CASE NO. 2020-00043
GLOVER CREEK SOLAR, LLC
RESPONSES TO HARVEY ECONOMICS' SECOND REQUEST FOR INFORMATION

I Construction phase activities –

Exhibit D

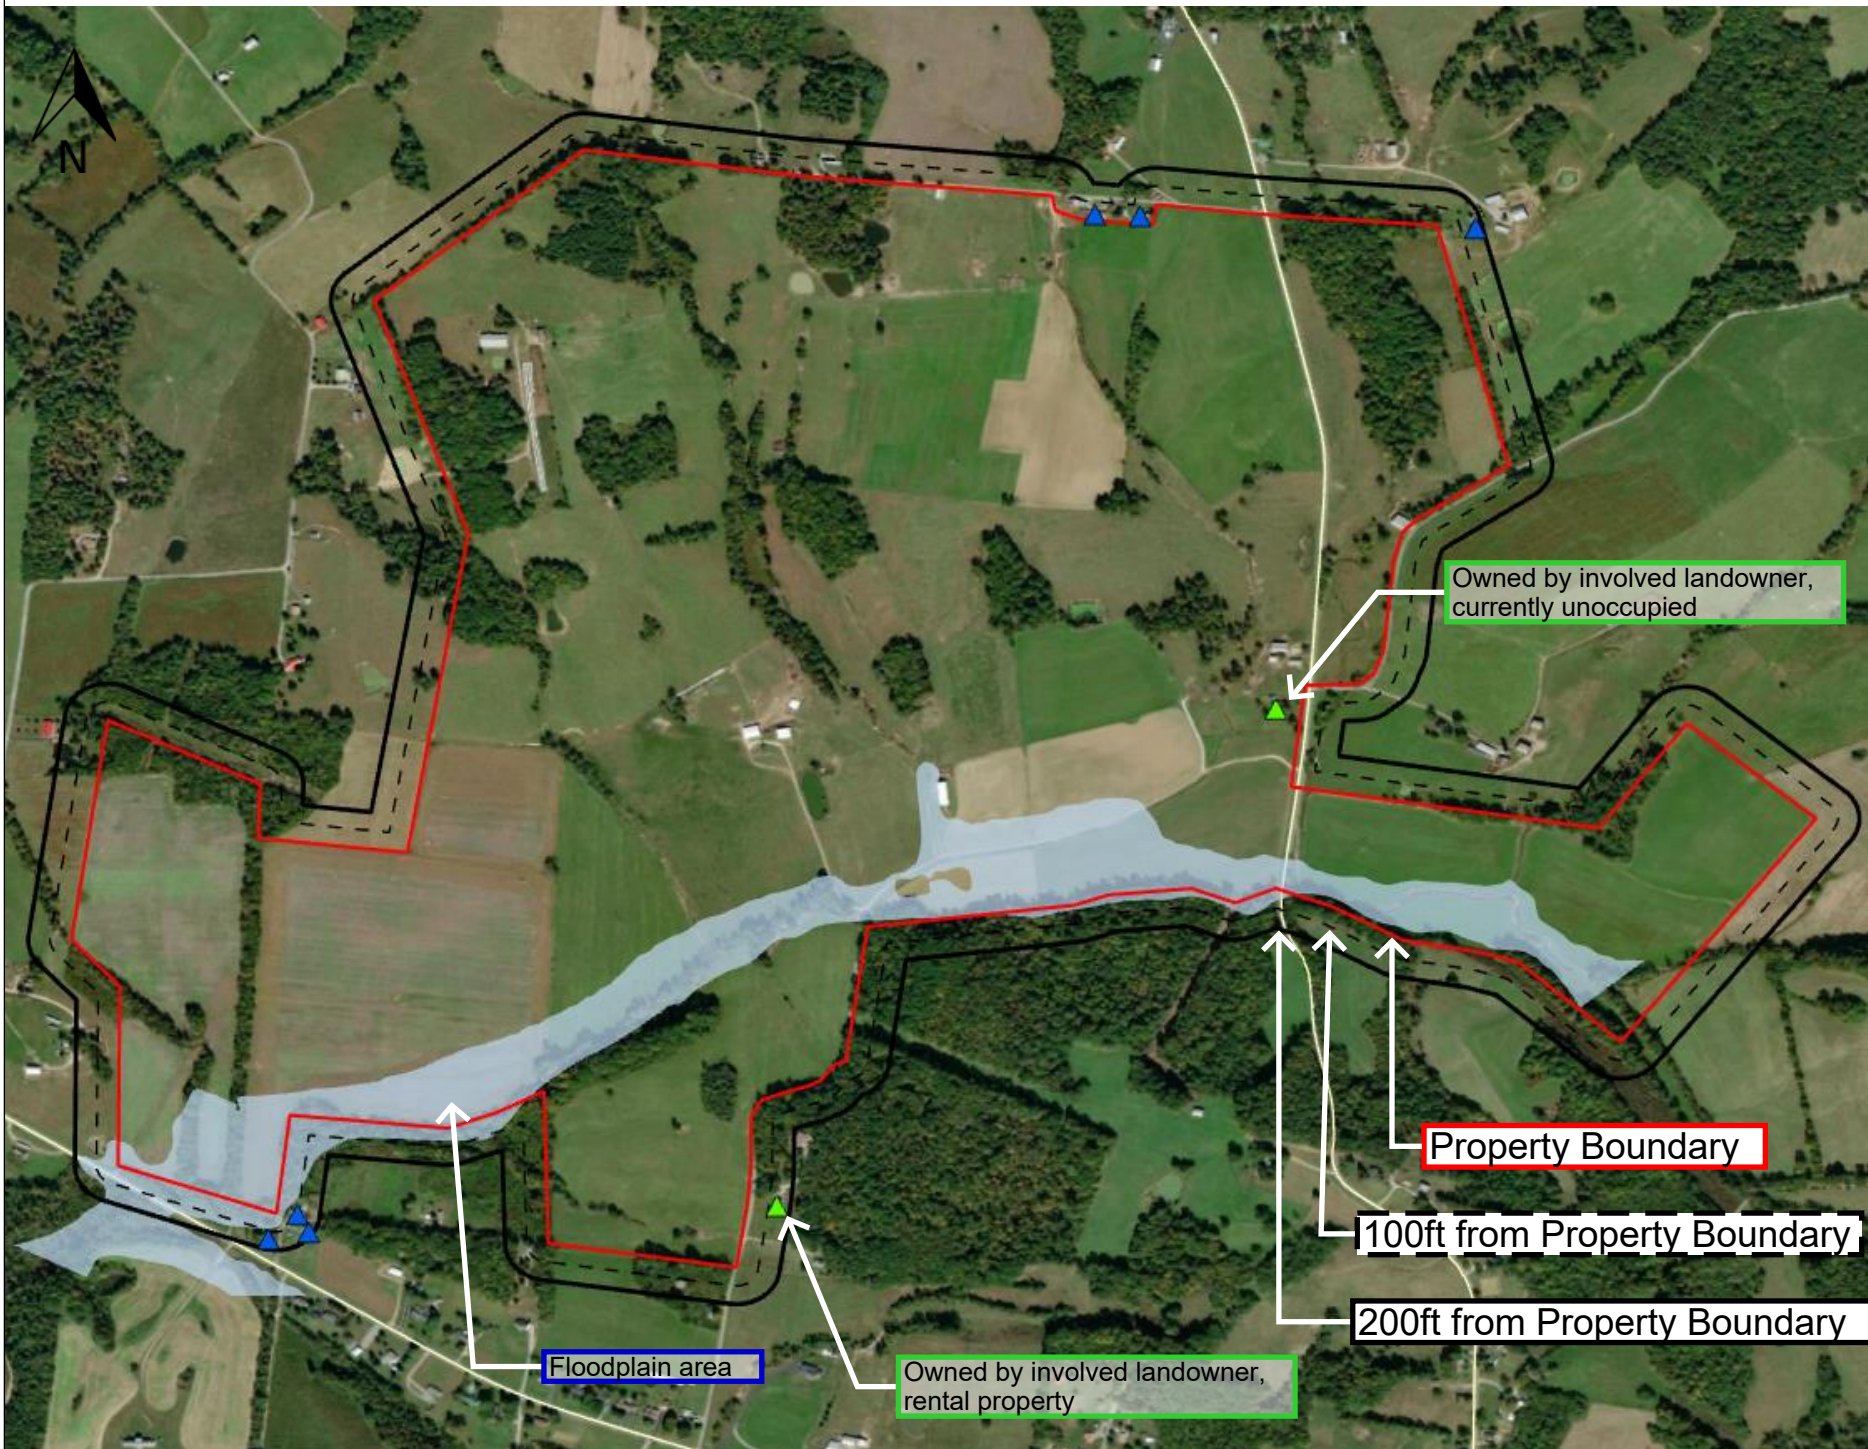
- B.** Number of residences by distance from site boundaries and panels—RFI#1 provided more information about the site boundaries and surrounding area, but it is still unclear what the distance is between each of the nearby residences, the site boundary and the nearest solar panel. A table would help for residences, moving outward to 1,000 feet, i.e., number of residences within 100 feet from boundary, number within 100 feet from nearest panel, number of residences within 200 feet from boundary, number within 200 feet from nearest panel, etc.

- IIA.** The staging area is more likely to be off of SR 640, due to the constraints of the floodplain and stream crossing at SR 90.
- IIIB.** Please see Exhibit C for a table of residences near the project in 100ft increments, and Exhibit D for a map showing the closest residences.

The minimum distance from a solar panel to the site boundary will be 100ft. No solar panels can be placed within the floodplain as marked on the map in Exhibit D, and so some residences that are 100 feet (for example) from property lines are more than 200 feet from panels.

1 house within 100ft of the site boundary is unoccupied and owned by an involved landowner, and 1 house within 200ft of the site boundary is a rental home owned by an involved landowner. These homes are shown in green on the map in Exhibit D.

There are 3 homes in the SW corner of the map in Exhibit D which are near the site boundary. These 3 homes will be much farther from panels than 100 feet due to the floodplain in the area.
